MIL-R-55016B(EL)
Amendment 3
1 May 1968

MILITARY SPECIFICATION

RADIO SET AN/TRC-68() (UNITS OF)

This amendment forms a part of Military Specification MIL-R-55016B(EL), dated 23 July 1963

FIGURE 1

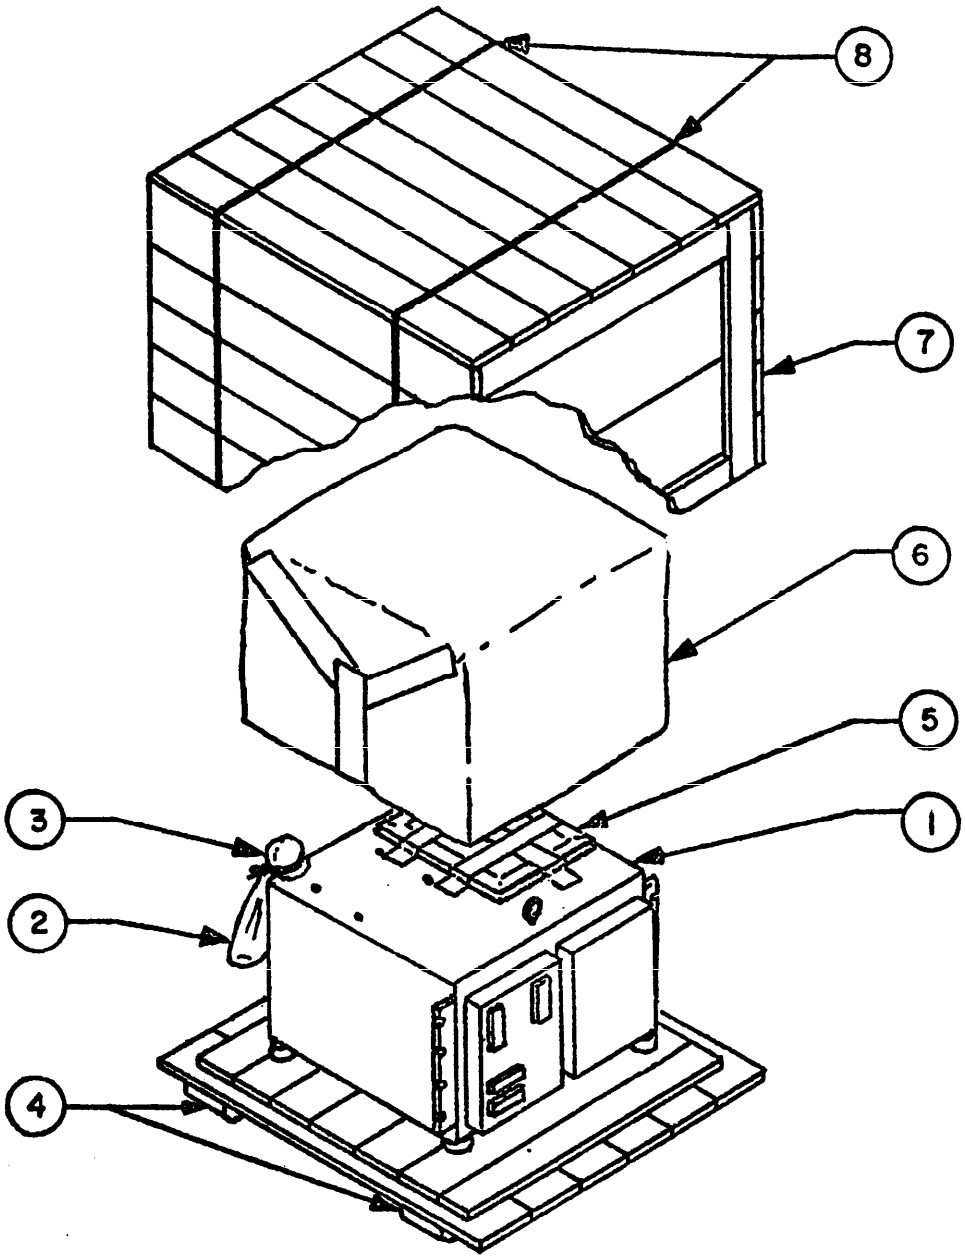
5.1.1.4.3 Radio Set AN/TRC-68(). Each radio set shall be packaged in accordance with items 1 through 5 of table VII and figure 1, items 1 through 5 of table VIII and figure 2 and items 1 through 15 of table IX and figure 3.

5.2.1.1 Receiver-Transmitter Group OA-2649()/TRC-68. Each receiver-transmitter group, packaged as specified in 5.1.1.4.3, shall be packed in accordance with items 6 through 8 of Table VII and Figure 1.
